7500 SUNSET BLVD

COMMUNITY INPUT REVISIONS

HOLLYWOOD HILLS WEST NEIGHBORHOOD COUNCIL

May 29, 2018

Expanded Mid-Block Courtyard & Outdoor Dining Plaza

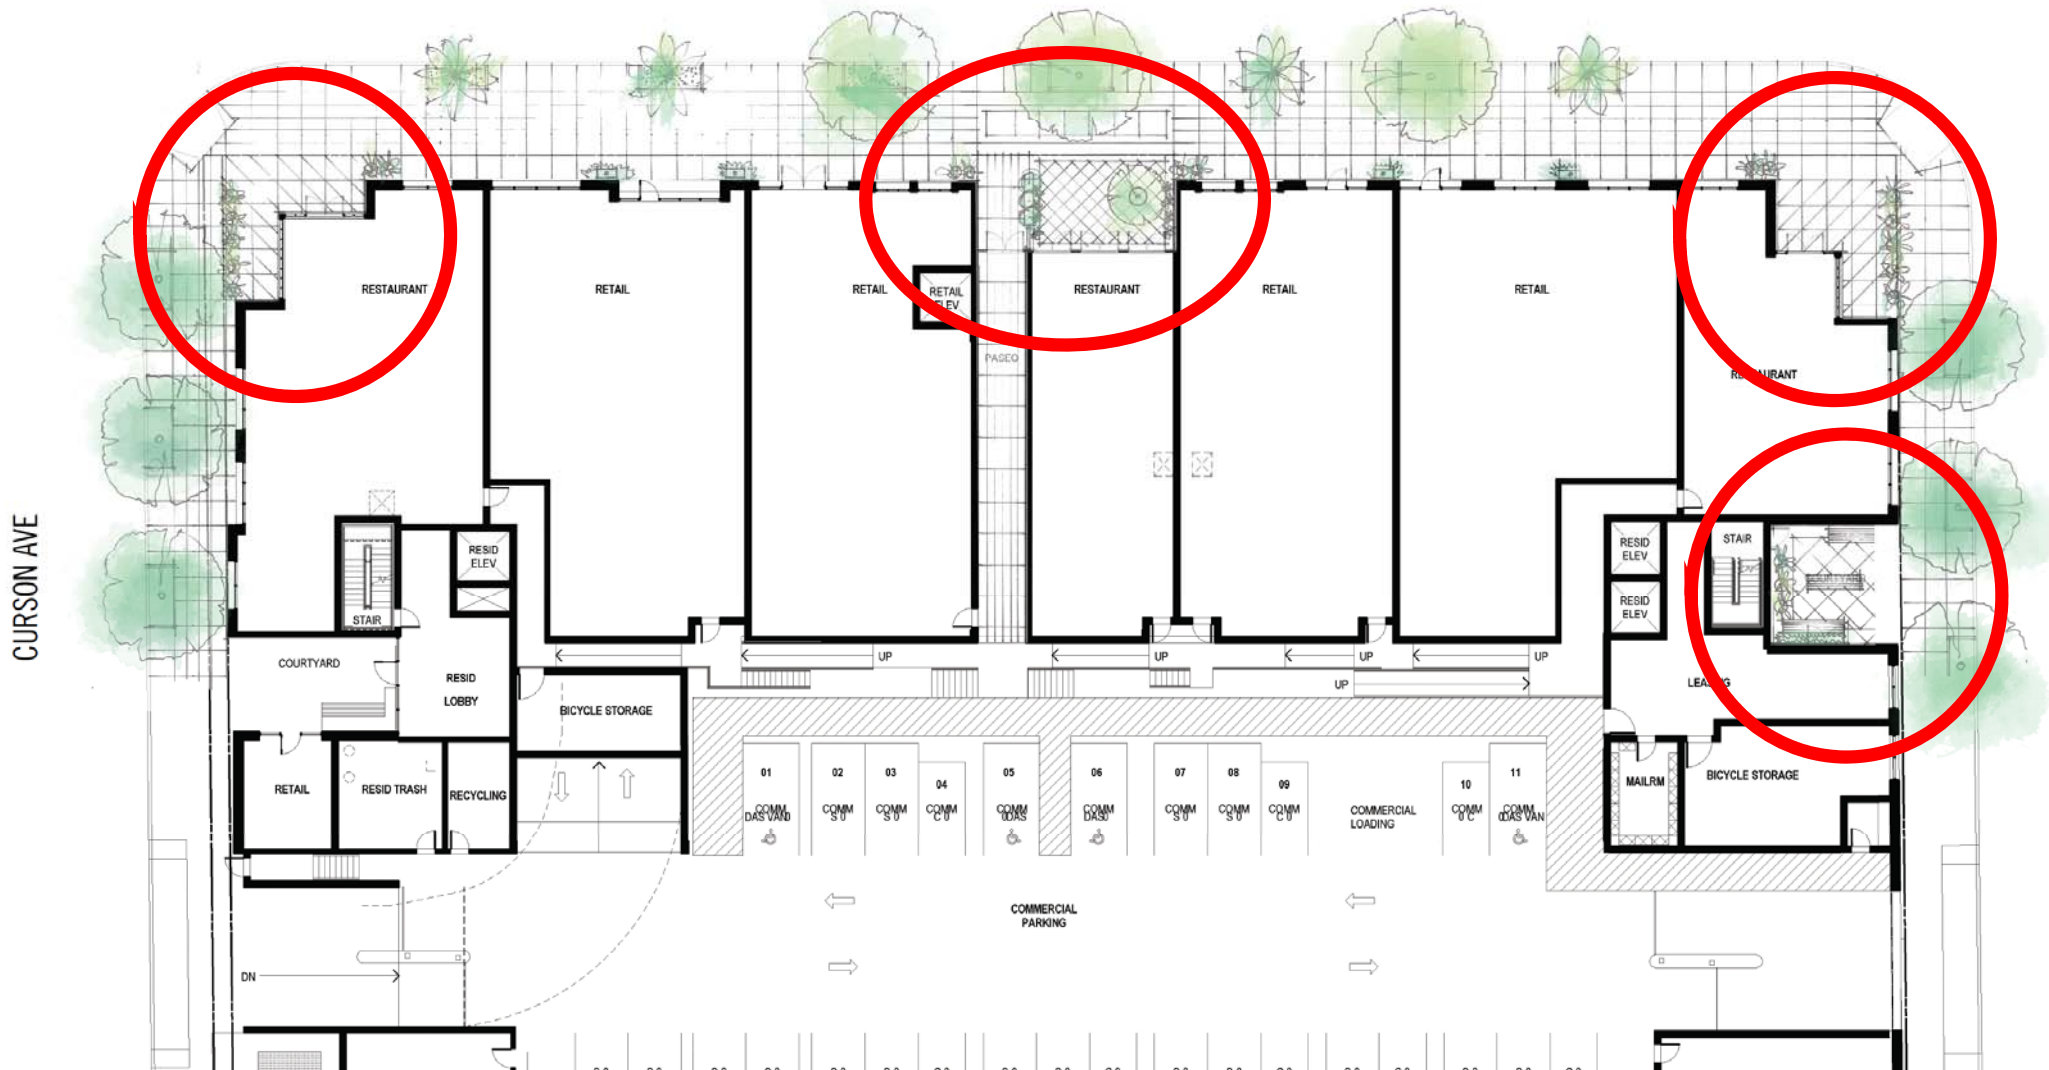
- Provide **additional publicly usable open space**, green space and landscaping along Sunset Blvd., Curson and Sierra Bonita, **including trees**. Agree that any **sidewalk dining will be within the proposed project's lot lines**, rather than on the already too narrow public sidewalks.

- **Publicly usable outdoor areas increased**
- **Urban Forestry to add new street trees**
- **Street Services to identify area streetscape standards**
- **All outdoor dining within private property lines**

Expanded Mid-Block Courtyard, Outdoor Dining Areas & Community Courtyard

REDUCED MASSING AND FLOOR AREA ALONG SUNSET BLVD

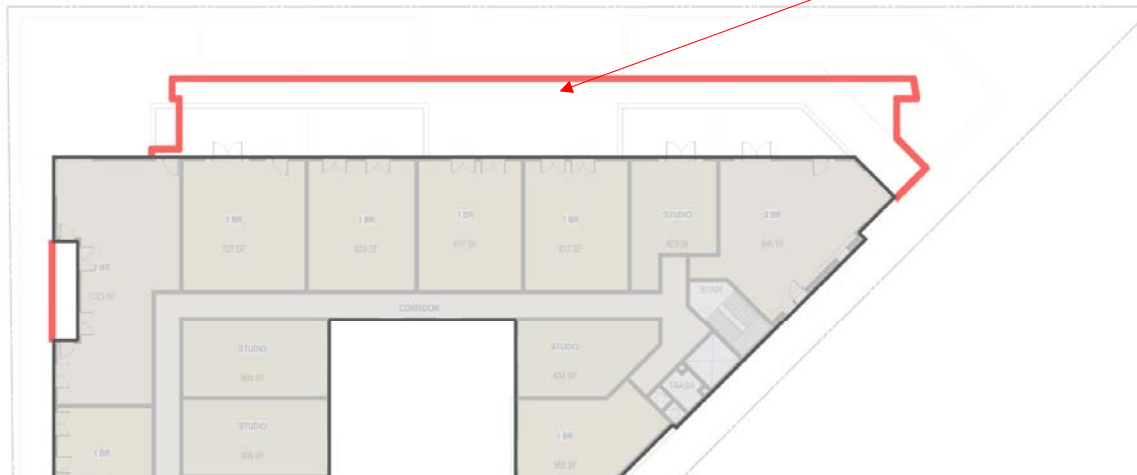
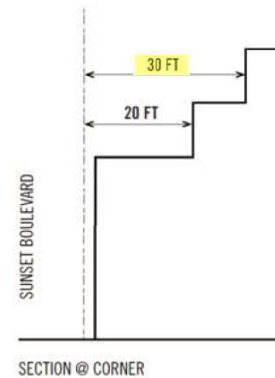
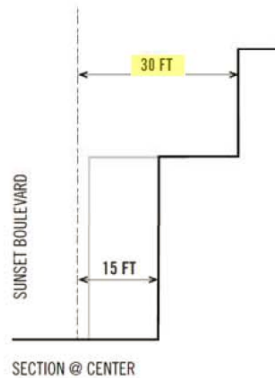
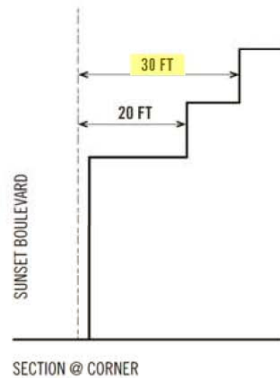
- Provide **larger step back from Sunset Blvd.** for the fourth floor, which is currently set back approximately 13 feet, in order to reduce the West and East buildings' massing and maintain more light on Sunset Blvd.

- ***INCREASED STEPBACK from Sunset to 30 ft***
- **Removed units**
- **Removed additional sq footage**
- **4th floor: 15-20 ft setback**
- **5th floor: 30 ft setback**

INCREASED STEPBACK
from Sunset to 30 ft:

- Removed units plus
- Additional sq footage

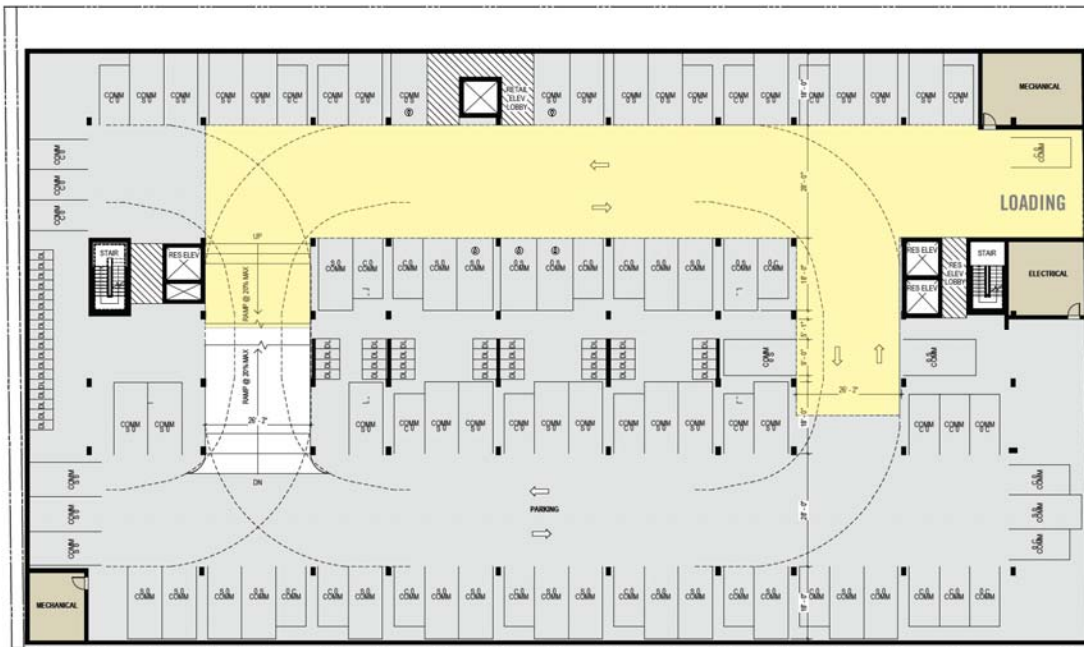
- Provide **at least 61 more parking spaces** despite being entitled to take a parking space reduction for bicycle parking spaces.

- **Expanded Public Parking by 90 spaces**
 - **Not using Bike Ordinance Reduction**
 - **Providing 31 excess spaces**

UNDERGROUND MOVE-IN/MOVE-OUT ZONES

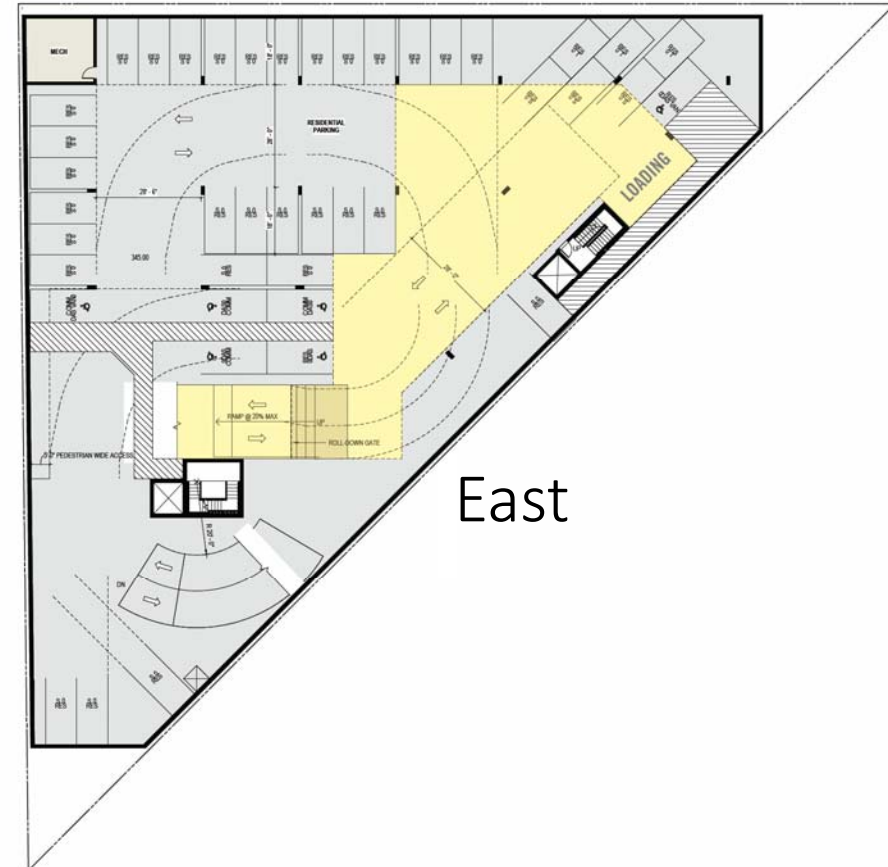
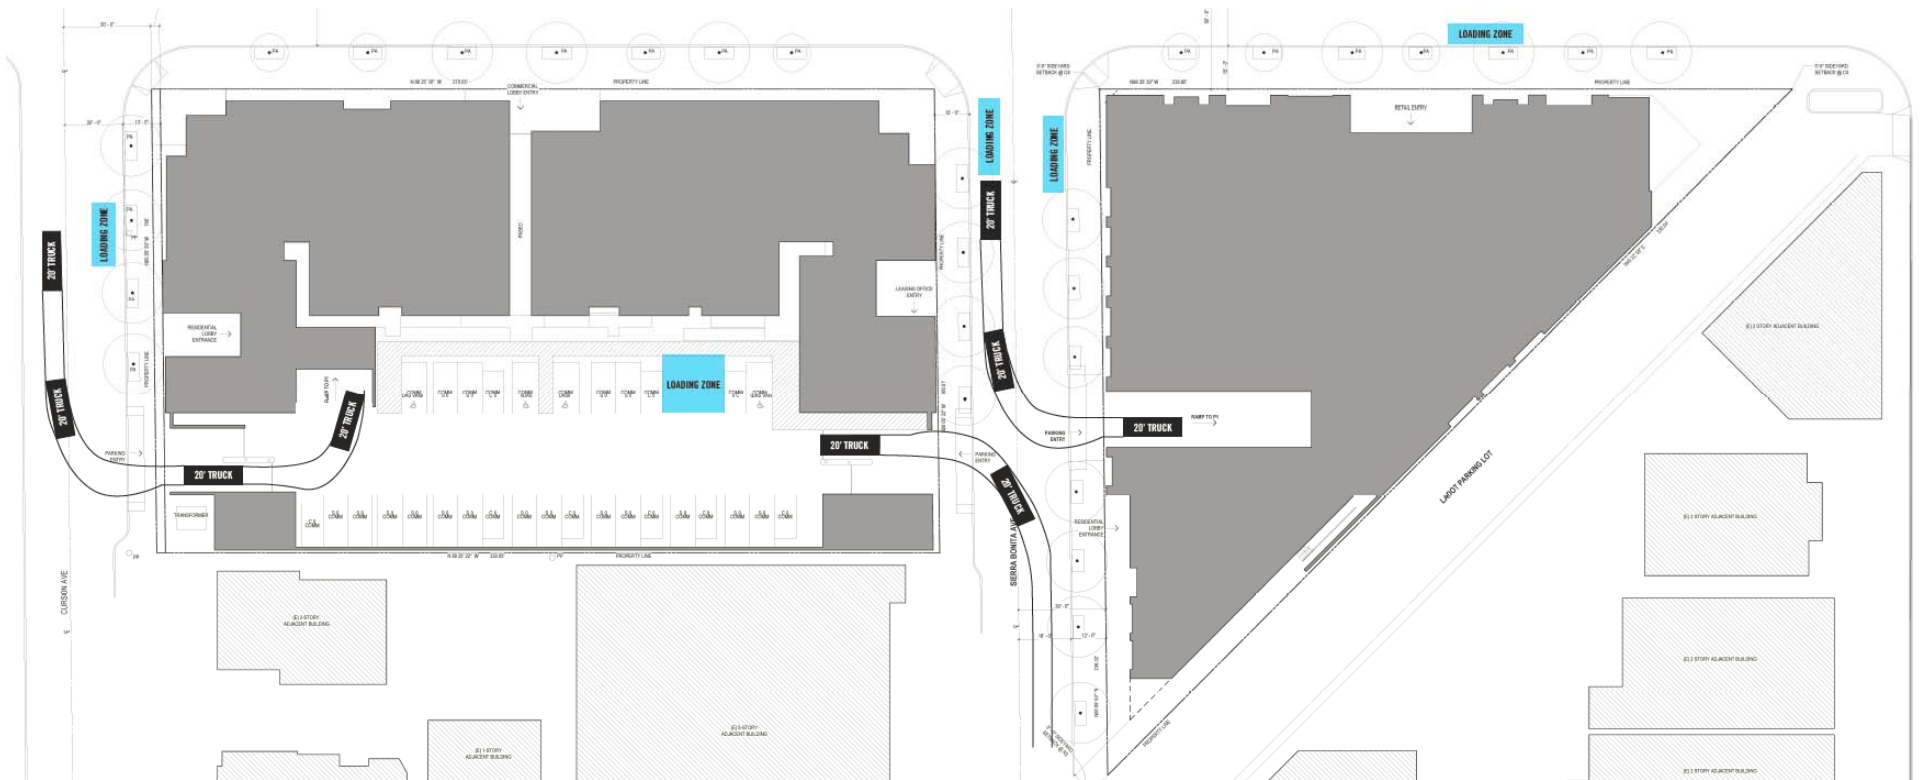
- Hire a traffic expert to solve the traffic problems with regard to ingress, egress and parking which are inherent in the current proposed traffic plan, which is inadequate.

- Updated Traffic Study:
 - Updated traffic counts
 - Studied neighborhood street segments
 - Expanded the list of Related Projects considered
 - Included Gelsons/grocery site
- Clarified access, loading, move-ins/move-outs at P1

STREET WIDENINGS IMPROVE TRAFFIC CIRCULATION

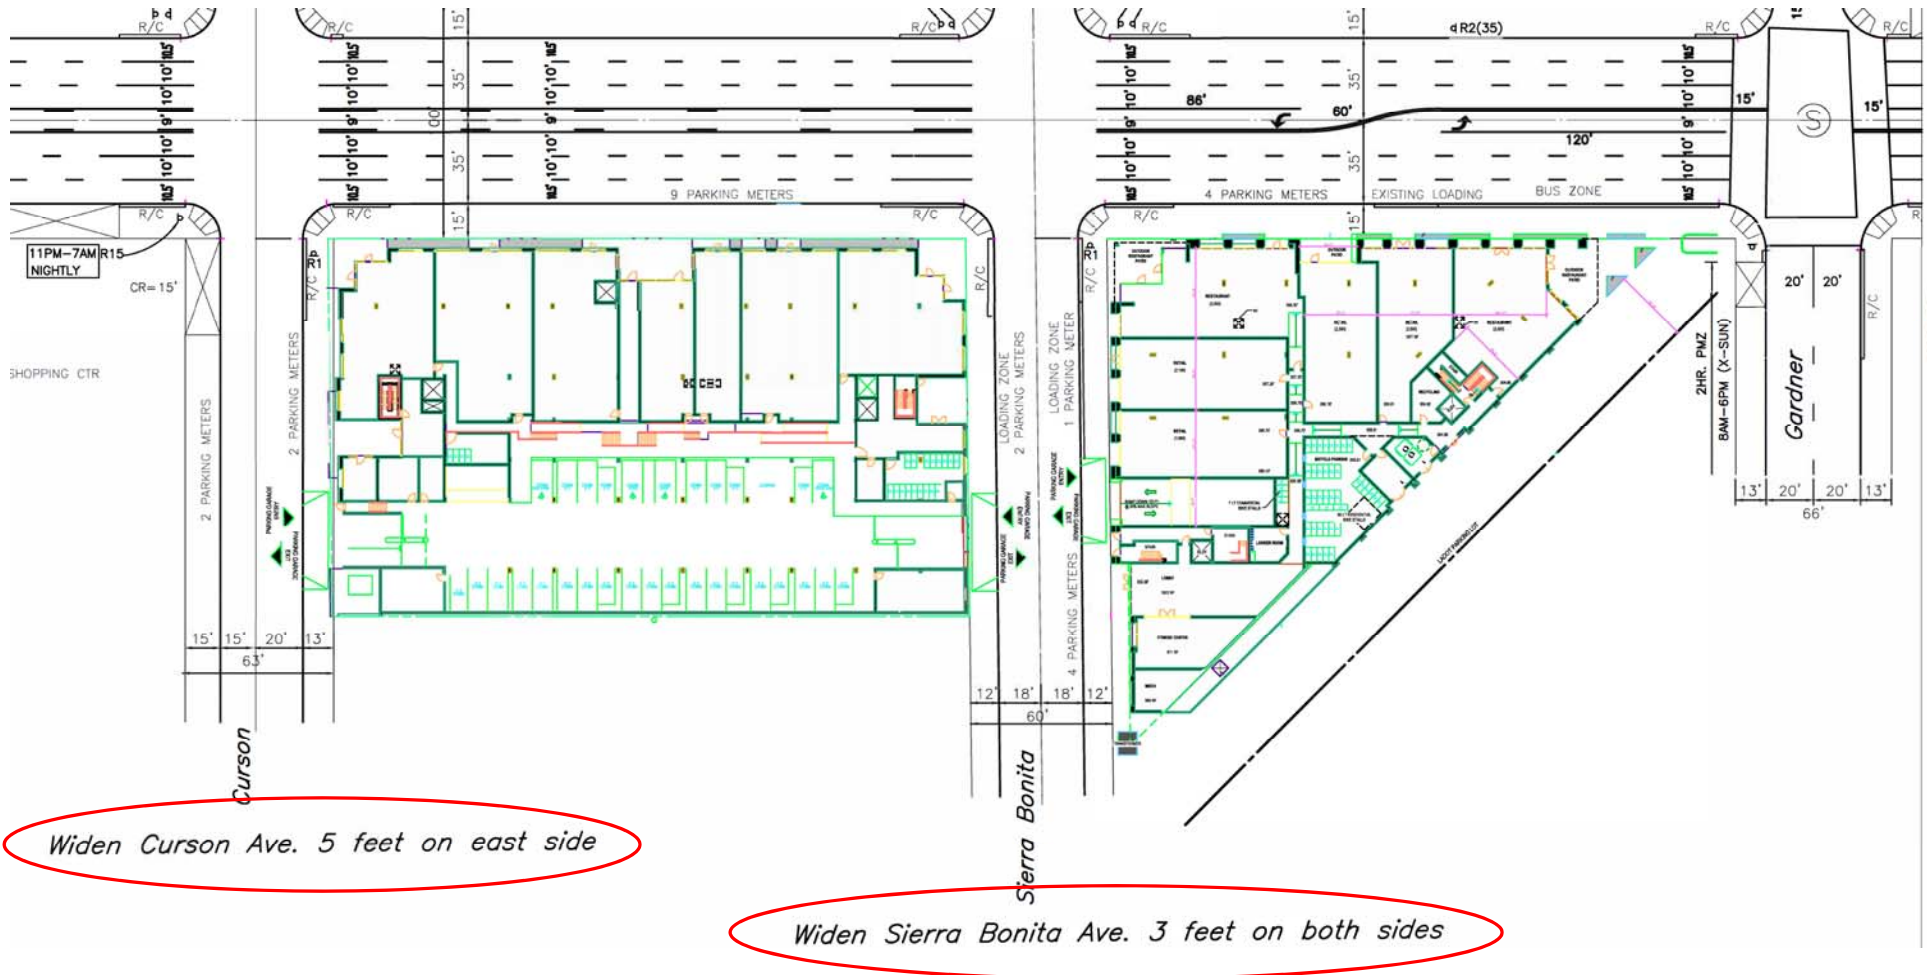
- Provide for intersection improvements at Sunset/Curson and Sunset/Sierra Bonita, and mid-block if tenants will be crossing between buildings to access commonly shared facilities, such as the pool and gym.

- Intersection improvements to continental crossings
- Curson widened 8 ft (10 ft sidewalks)
- Sierra Bonita widened 6 ft (12 ft sidewalks)
- Sunset w/ 15 ft sidewalks
- LADOT Parking lot to remain as-is
